Office Action Summary

10/821,624

DUNKLEY ET AL.

DETAILED ACTION

PRIOR ART
4,069,319
FIG. 3

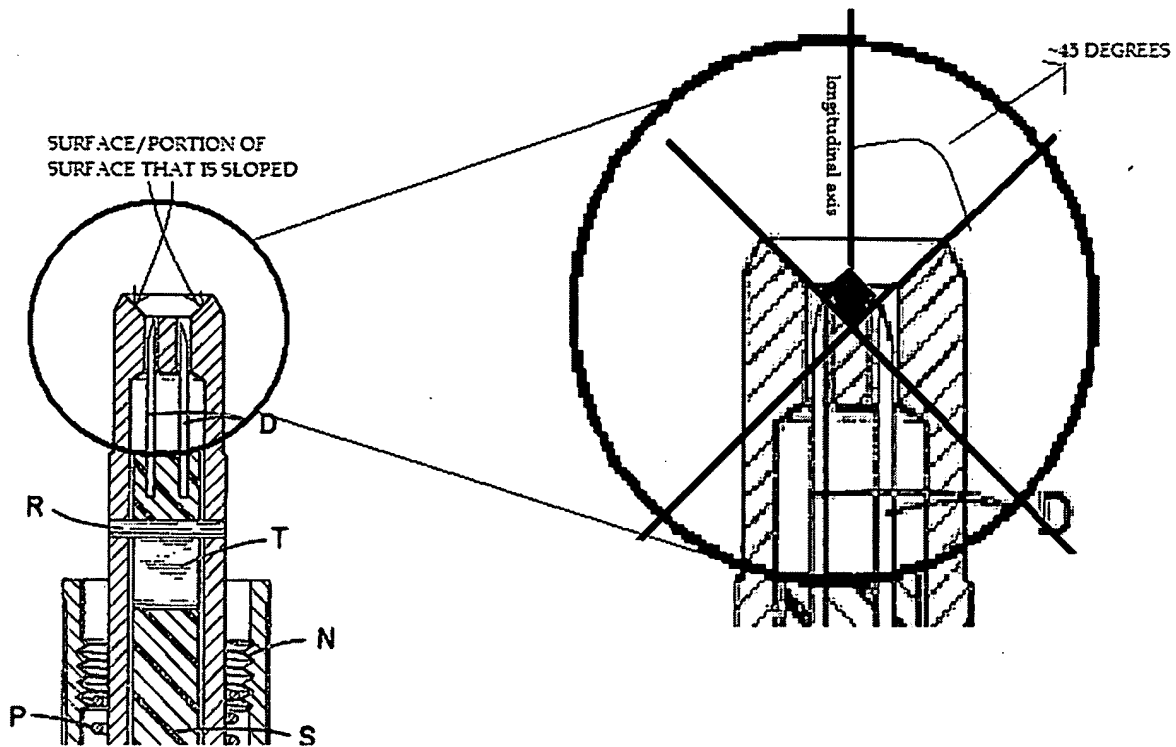
a puncturing mechanism (fig.3, M-T) within the housing, the puncturing mechanism comprising an alignment guide (L) and a puncture member (D), wherein the alignment guide comprises a surface (bevel depicted at one end of L, see labeled fig.3 attached below) adapted to contact the capsule while the puncture member is advanced into the capsule to create an opening (col.2 lines 65-68, col.3 lines 1-10) in the capsule, and wherein at least a portion of the surface is sloped at an angle which is less than 55 degrees relative to the longitudinal axis of the capsule (see labeled fig.3); and an end section (A) associated with the housing, the end section sized and shaped to be received in a user's mouth or nose so that the user may inhale through the end section to inhale aerosolized pharmaceutical formulation that has exited the capsule through the opening created in the capsule (col.3 lines 10-16).

As to claim 2, Valentini discloses wherein the surface is sloped at an angle, which is from 35 to 55 degrees relative to the longitudinal axis of the capsule (see labeled fig.3).

As to claim 3, Valentini discloses wherein the surface is sloped at an angle, which is from 37 to 50 degrees relative to the longitudinal axis of the capsule (see labeled fig.3).

As to claim 4, Valentini discloses wherein the surface is sloped at an angle of about 45 degrees relative to the longitudinal axis of the capsule (see labeled fig.3).

As to claim 7, Valentini discloses wherein the wherein the surface is sloped at an angle which less than 55 degrees relative to the longitudinal axis of the puncture member (see labeled fig.3).

As to claim 8, Valentini discloses wherein the surface is sloped at an angle which less than 55 degrees relative to the longitudinal axis of the chamber (see labeled fig.3).

As to claim 9, Valentini discloses wherein the wherein the surface is sloped at an angle which less than 55 degrees relative to an inhalation direction (see labeled fig.3).

As to claim 11, Valentini discloses wherein the wherein the surface is sloped at an angle which less than 55 degrees relative to the direction of movement of the surface (see labeled fig.3).

As to claim 12, Valentini discloses wherein the surface comprises one or more protrusions and wherein the one or more protrusions (see labeled fig.3) are adapted to contact the capsule (col.2 lines 65-68).
